Access Compliance Report

Public Rights-of-Way

Intersection ID: 42534	Main Street: CASTLETOWN_HOUSE_DR	Cross Street: RUSSBOROUGH_CT	Location: SE
ADA ID: DF09C815E2BC	Ramp Type: PerpDiag	Initial Pass/Fail: Fail	Overall Compliance: No
Severity Score: 46.25			
Codes/Mitigation Info/Possible Solution		Field Measurements/Component Compliance

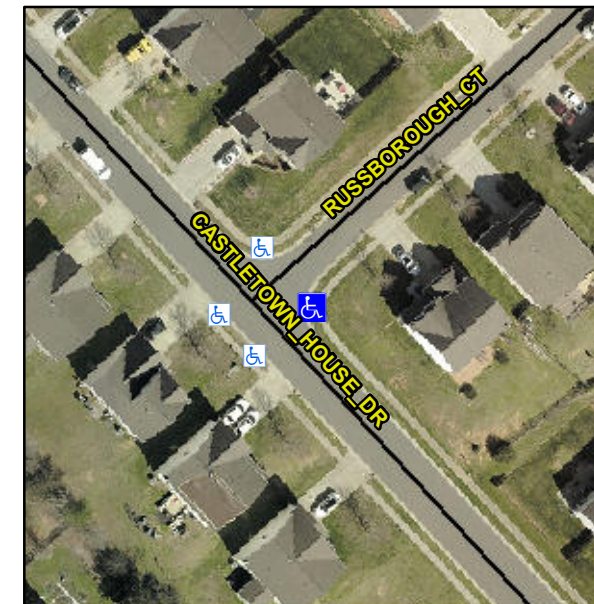
R304.5.1, R304.2.2, R304.5.3

Compliance	Description	Data	Compliance	Description	Data
N/A	Ramp Length (in)	51.0	No	Ramp Slope (%)	10.0
No	Ramp Width (in)	45.0	No	Ramp XSlope (%)	11.1
N/A	Flare Type LT	N/A	N/A	Flare Type RT	N/A
N/A	Flare Slope LT (%)	N/A	N/A	Flare Slope RT (%)	N/A
N/A	Flare Traversable LT?	N/A	N/A	Flare Traversable RT?	N/A
N/A	Landing Length (in)	N/A	N/A	DWS Provided?	N/A
N/A	Landing Width (in)	N/A	N/A	DWS Contrast?	N/A
N/A	Landing Slope (%)	N/A	N/A	DWS Length (in)	N/A
N/A	Landing X Slope (%)	N/A	N/A	DWS Full Width?	N/A
N/A	Landing Curb? (Y/N)	N/A	N/A	DWS Offset (in)	N/A
N/A	Shared Landing?	N/A			
N/A	Gutter Ponding?	N/A	N/A	Gutter Slope (%)	N/A
N/A	Gutter Lip Ht (in)	N/A	N/A	Gutter X Slope (%)	N/A
N/A	Painted X Walk1?	No	N/A	Painted X Walk2?	No
	X Walk 1 Direction	To NW		X Walk 2 Direction	To SW
N/A	X Walk 1 Width (in)	N/A	N/A	X Walk 2 Width (in)	N/A
	X Walk 1 Slope (%)	6.2		X Walk 2 Slope (%)	1.2
	X Walk 1 X Slope (%)	9.3		X Walk 2 X Slope (%)	7.6

Remove & Replace Curb Ramp With Two New Directional Ramps or Equivalent.
